RECALL 20V-601: HIGH-VOLTAGE BATTERY RECALL

This Service Information Bulletin (Revision 10) replaces SI B61 23 20 **dated April 2021**.

What's New (Specific text highlighted):

- Procedure Section (HV work disclaimer)
- Parts Section

SP44 HV Battery (G05) modules-

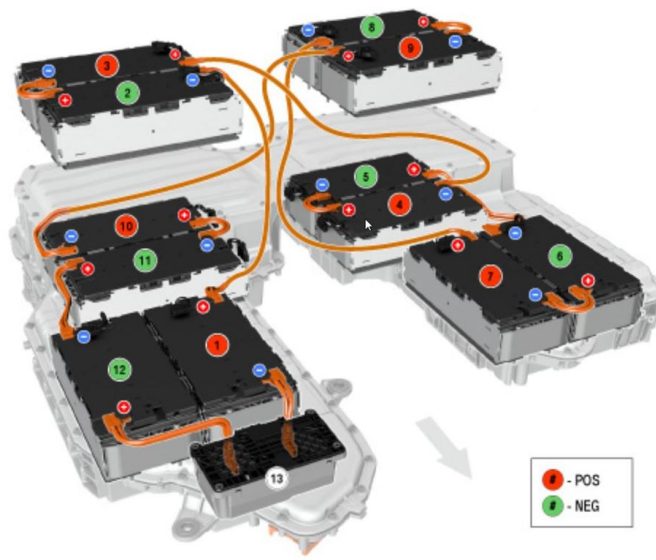
Modules are designed as Positive and Negative modules (with different orientation and part numbers). When replacing modules, verify in EPC the correct part (POS/NEG) and reinstall according to their original position. See below.

Use EPC diagram to verify the correct module part number (01/02) for NEG or POS modules.

Use the illustration on the right to match the part# with the correct module installation location.

- Module 12 is **NEG (01)**
- Module 1 is **POS (02)**
- Module 11 is **NEG (01)**
- Module 10 is **POS (02)**
- Module 2 is **NEG (01)**
- Module 3 is **POS (02)**
- Module 8 is **NEG (01)**
- Module 9 is **POS (02)**
- Module 5 is **NEG (01)**
- Module 4 is **POS (02)**
- Module 6 is **NEG (01)**
- Module 7 is **POS (02)**

SP41 HV Battery (G01/G20/G20/G12) modules-

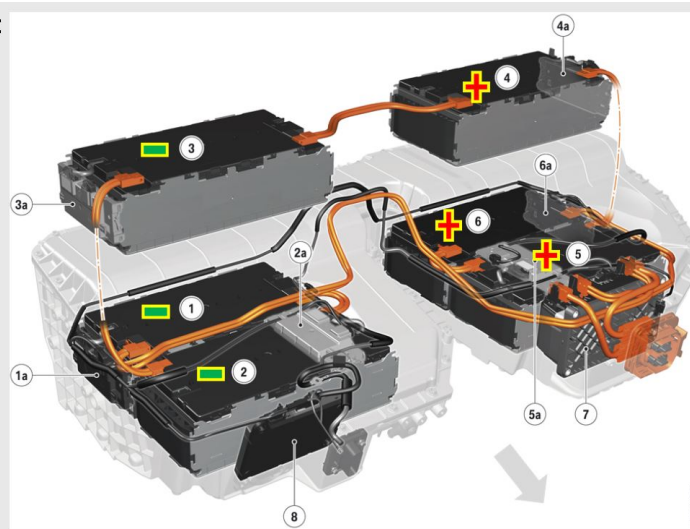
Use EPC diagram to verify the correct module part number (01/02) for NEG or POS modules.

Use the illustration on the right to match the part# with the correct module installation location.

- Module 1 is **NEG (01)**
- Module 2 is **NEG (01)**
- Module 3 is **NEG (01)**
- Module 4 is **POS (02)**
- Module 5 is **POS (02)**
- Module 6 is **POS (02)**
